Access Compliance Report

Public Rights-of-Way

(Curb Ramps)

Intersection ID: 48949	Main Street: OLD_STONE_CROSSING_DR	Cross Street: DAVID_JENNINGS_AV	Location: SW
ADA ID: B7FD61FAB313	Ramp Type: BlendTrans1	Initial Pass/Fail: Fail	Overall Compliance: No
Severity Score: 8.75			
Codes/Mitigation Info/Possible Solution		Field Measurements/Component Compliance

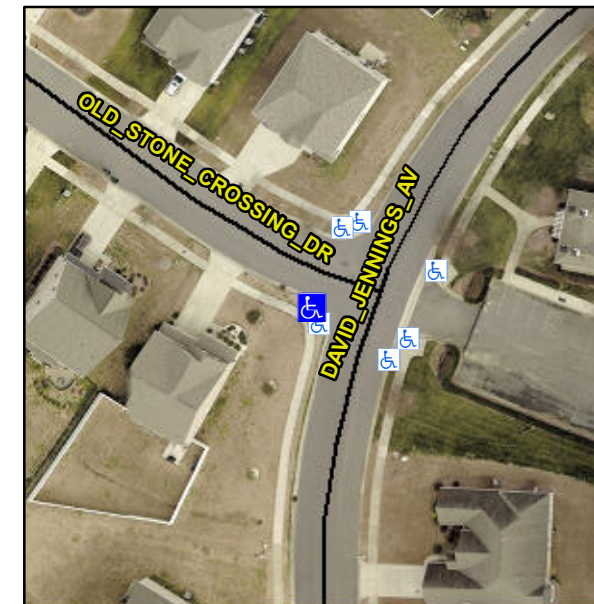
CURB LIP 0.5

Not Found, R304.5.1

Remove & Replace Curb Ramp With Two New Directional Ramps or Equivalent.
